Office Action Summary

10/596,922

BACCIOTTINI, CARLO

DETAILED ACTION

Figure F1: Mannava discloses the reference point and angle in between reference point and axial hole

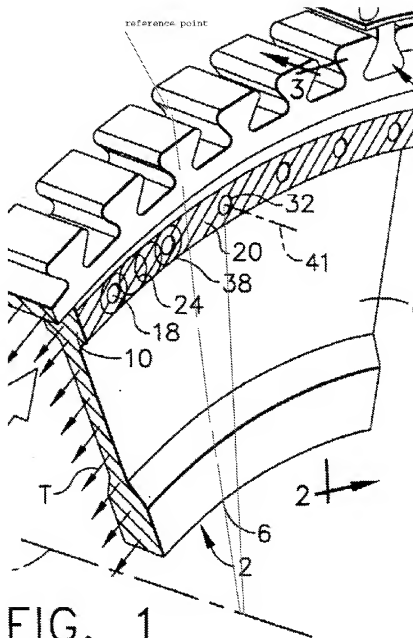
each slot has a reference point for placing a corresponding vane, an angle between the reference point of a slot and a central point of adjacent hole of the series of holes, and the reference point is defined by an intersection of (i) of an axis of the slot in a middle side section of the disk with (ii) an extension of a side surface of the outer portion (Fig. F1).

each slot has a reference point for placing a corresponding vane, an angle between the reference point of a slot and a central point of adjacent hole of the series of holes, and the reference point is defined by an intersection of (i) of an axis of the slot in a middle side section of the disk with (ii) an extension of a side surface of the outer portion (Fig. F1).
